IMO_REP_0053

PRELIMINARY ASSESSMENT REPORT

APPLICANT: *Hydro One Networks Inc.*
PROJECT: *Manby TS: Remove Synchronous Condensers*

CAA ID No. *2001-049*

FIGURE 1
MANBY TS : REMOVAL OF SYNCHRONOUS CONDENSERS

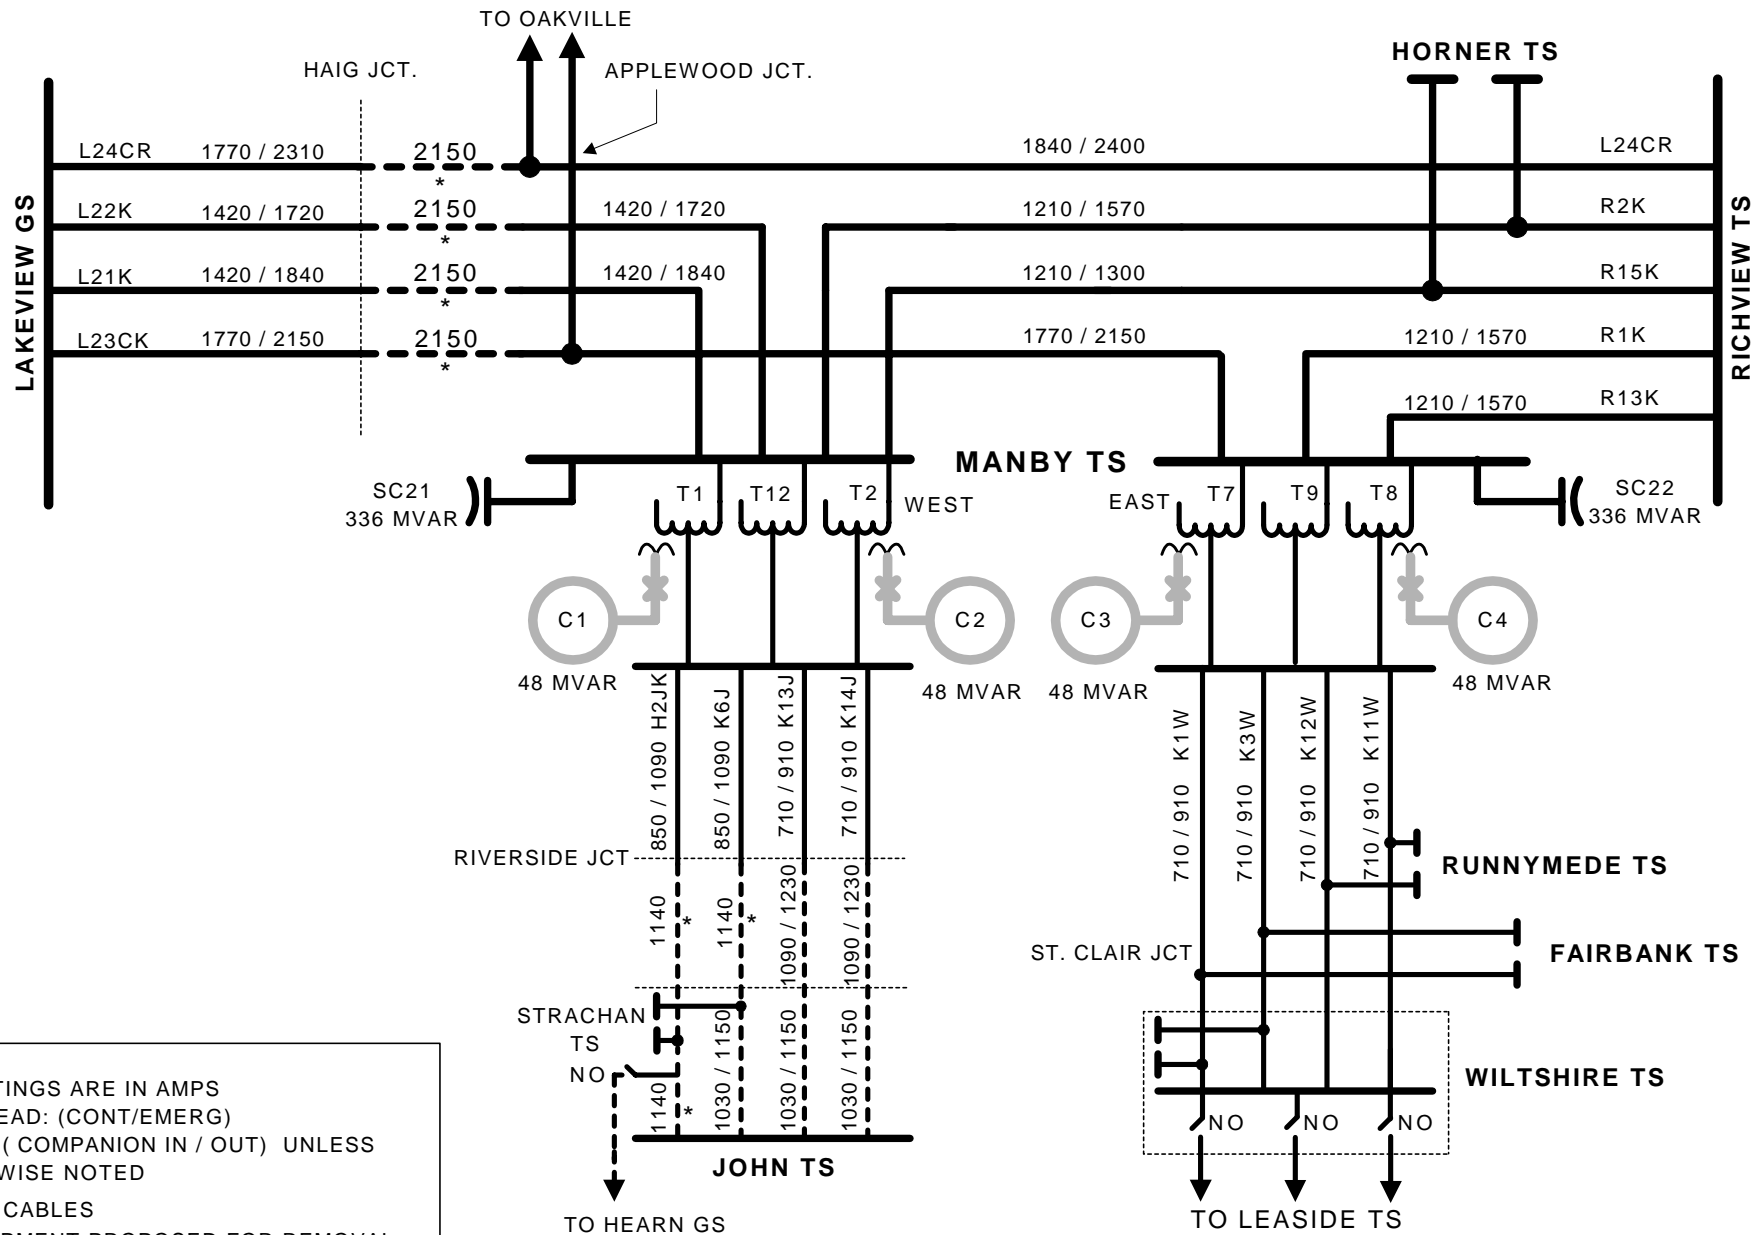
Manby TS is a major 230-115 kV autotransformer and switching station supplying approximately 800 MVA or 15% of the city of Toronto load. The station is supplied via the Richview TS x Lakeview GS 230 kV circuits as shown in Figure 1. The station consists of six 230-115 kV autotransformers supplying eight 115 kV circuits. These circuits supply five 115-13.8 kV transformer stations which supply the City of Toronto. As shown in Figure 1, Manby TS consists of two separate 230/115 kV switchyards, designated Manby East and Manby West

Also, as shown in Figure 1, there are two 230 kV, 336 MVAR capacitor banks, one at Manby East and one at Manby West. These were installed in the late 1990's to provide voltage support in the area.

Hydro One Networks Inc. has proposed to permanently disconnect and remove the four synchronous condensers (C1-C4) and associated equipment at Manby TS.
